LVT-to-LVTH Conversion

SCEA010
January 1999

Figure 1. LVT16244A at 85°C With Input Biased to Drive Output High When Active

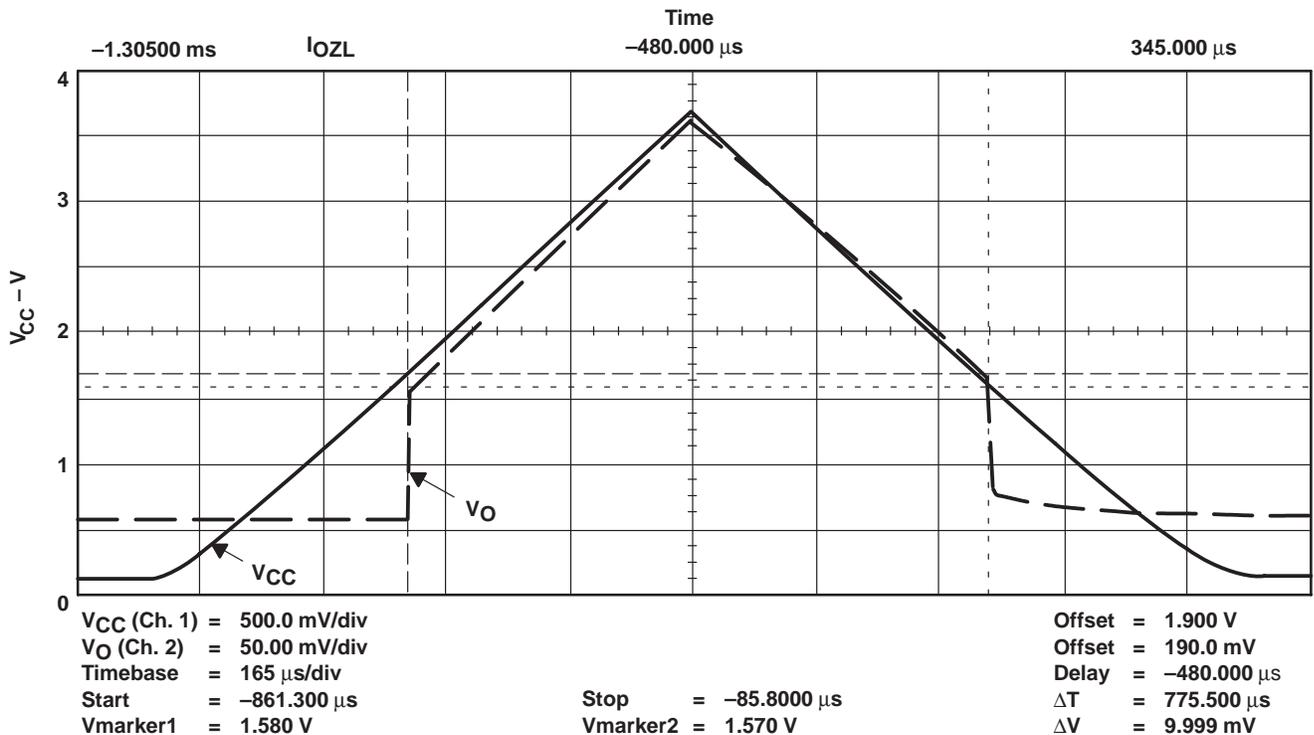
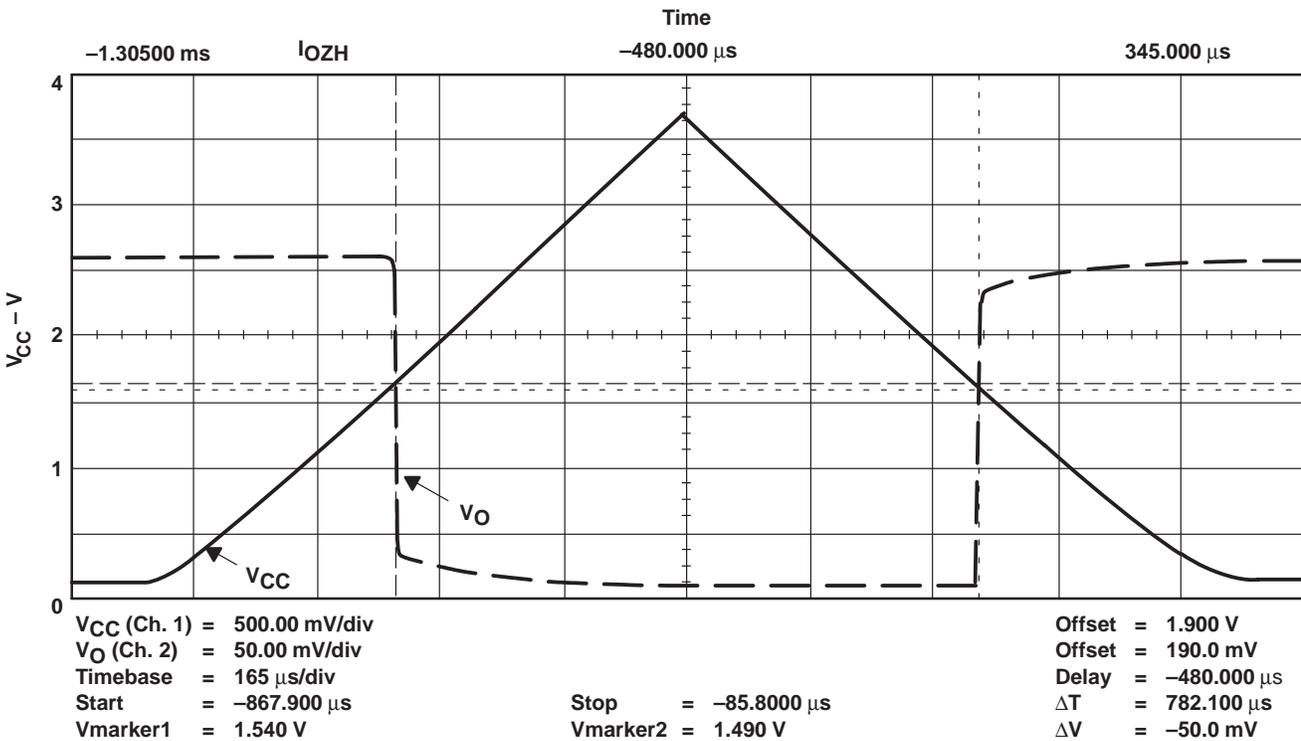
Figures 1 and 3 show that, once the V_{CC} of the LVT16244A exceeds about 1.5 V on power up or that the V_{CC} drops below about 1.5 V on power down, the outputs become active or enter the high-impedance state, respectively. Figures 2 and 4 show that once the V_{CC} of LVTH16244A exceeds about 2 V on power up or that V_{CC} drops below about 2 V on power down, the outputs become active or enter the high-impedance state, respectively.

These figures demonstrate that, while the original LVT devices do exhibit a high-impedance characteristic during the initial phase of power up and final phase of power down, they do so only below V_{CC} levels that are too low to provide adequate margin versus the I_{OZPU} and I_{OZPD} specifications. The new LVTH devices, with the deliberately designed High-Impedance State During Power Up and Power Down feature, do provide adequate margin to the specifications.

Figure 5. V-I Characteristics for LVT16244A and LVTH16244A Bus-Hold Inputs

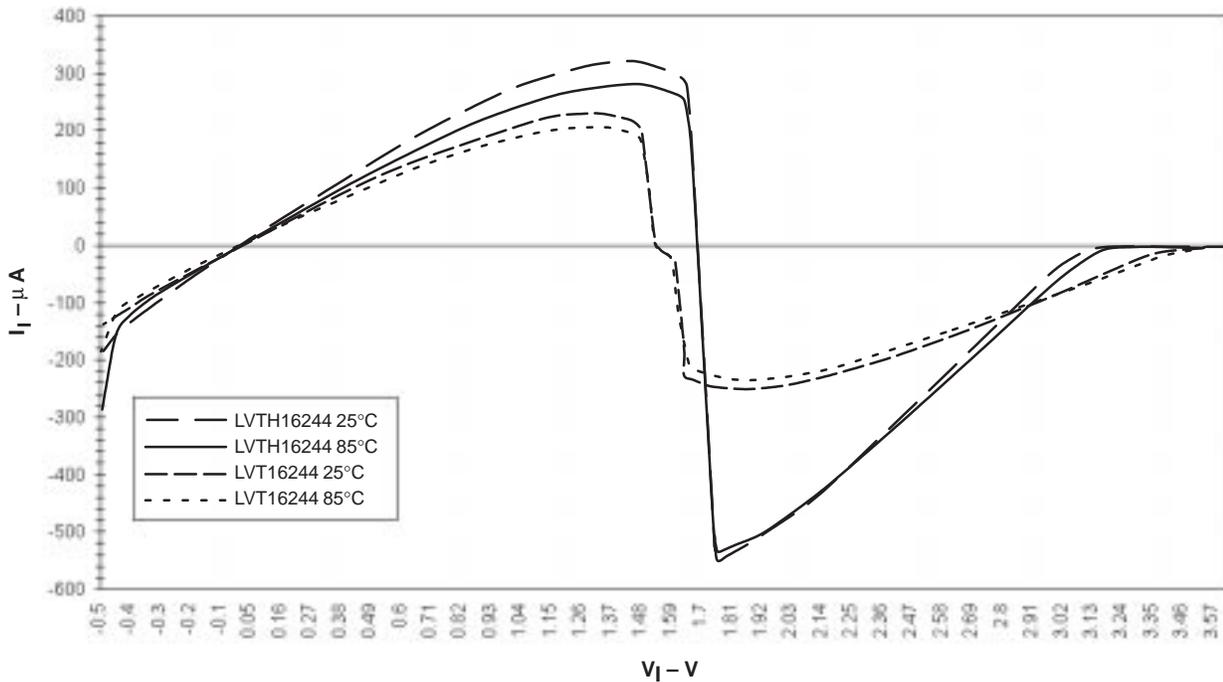
LVTH devices in the redesigned product line have one of two versions of the bus-hold circuit. The devices with Type-A circuits have a recommended overdrive current of 750 μA . The devices with Type-B circuits have a recommended overdrive current of 500 μA . The original LVT family had a recommended overdrive current of 500 μA . See Table 6 for a list of LVTH devices that have the Type-A circuit and those that have the Type-B circuit. Overdrive current is the current required to ensure that a bus-hold input is switched from one logic state to the other. Devices with the Type-B circuit are not significantly different from the LVT devices they replace. However, devices with the Type-A circuit require more overdrive current than the LVT devices they replace. This increase in overdrive current on devices with a Type-A circuit must be comprehended when converting an application to use the LVTH device, especially if pullup or pulldown resistors are used at the inputs. Figure 5 shows a comparison of the V-I characteristics of a bus-hold data input on the LVT16244A and the replacement LVTH16244A.

Although bus hold eliminates the need to tie-off unused data inputs, there are other situations that require tie-off. When tie-off of inputs is required, the pullup or pulldown mechanism must be able to sink or source the recommended overdrive current to ensure that the input will be pulled to the desired state. See Table 7 for the recommended resistor size for the most common tie-off voltages.
